Product Highlights

- The BL Series of Back-lit Backlights offer a low profile design with a planar, back-lit array of LEDs. Model numbers include the BL0202, BL0404 and BL0808.

Change Notice

PCN No: 170

PCN 152

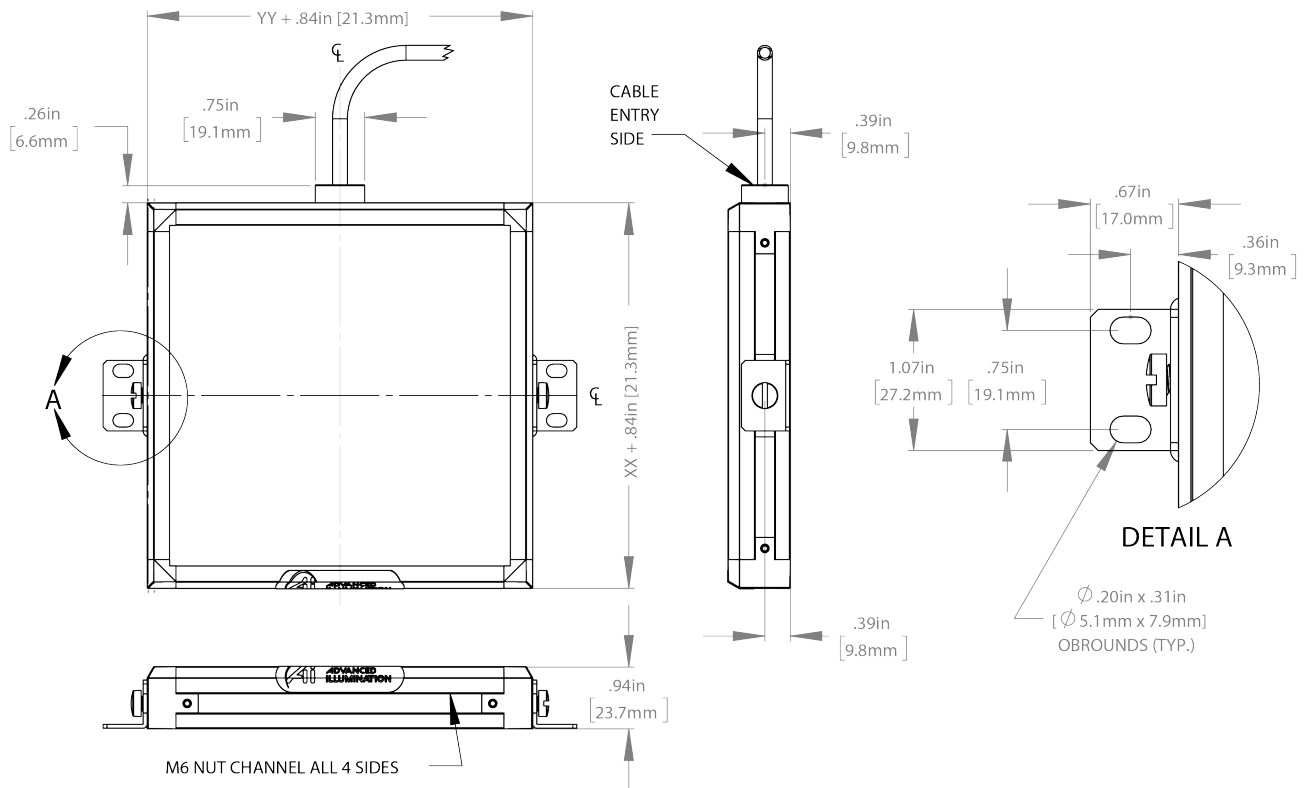
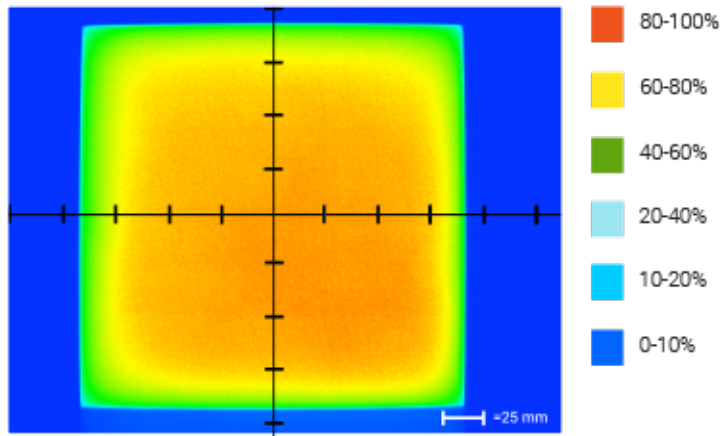
In an effort to improve our products, Advanced illumination (Ai) will be updating the internal drivers and white LEDs used in the BLXXYY, CBXXYY, FDXXYY, BL128, BL193, and BL245. This change will result in white lights seeing a brightness increase of roughly 70% while maintaining equal pricing for small configurations and reduced pricing for large configurations. Excluding the BL128, 24V configured units will experience a current draw shift from 20mA to 30mA per sq. inch for 470nm, 520nm and white units while controller configured units will see a current draw shift from 15mA to 18mA per sq. inch for the same color configurations. Color temperatures will remain unchanged.

The LED upgrade and internal driver update for white color configurations will take place September 15th. The internal driver updates will occur November 9th for 470nm and January 7th for 520nm.
